GoMoto 4.3

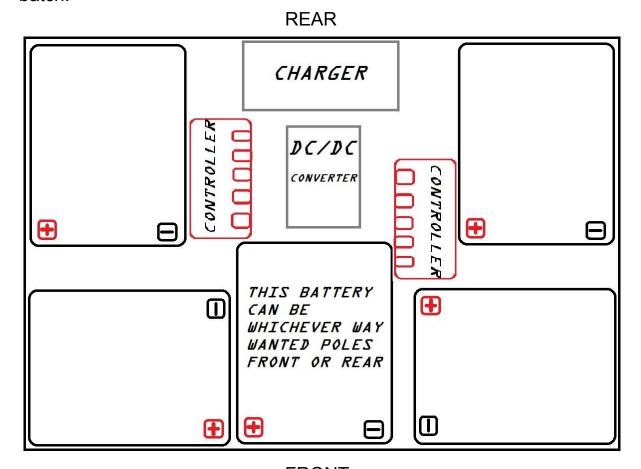
- -Batteries might be slightly different in size.
- -We have just got information for the latest batch that batteries are one centimeter longer than the original ones. (different manufacturer).
- -You need to switch one battery cable to a longer version and some self-drilling screws (parker screws) for relocating the components inside the battery compartment.
- -Usually only one controller and converter has to be moved around 10cm closer to the charger.
- -Here's a map of how we assemble the batteries here with the new batch.
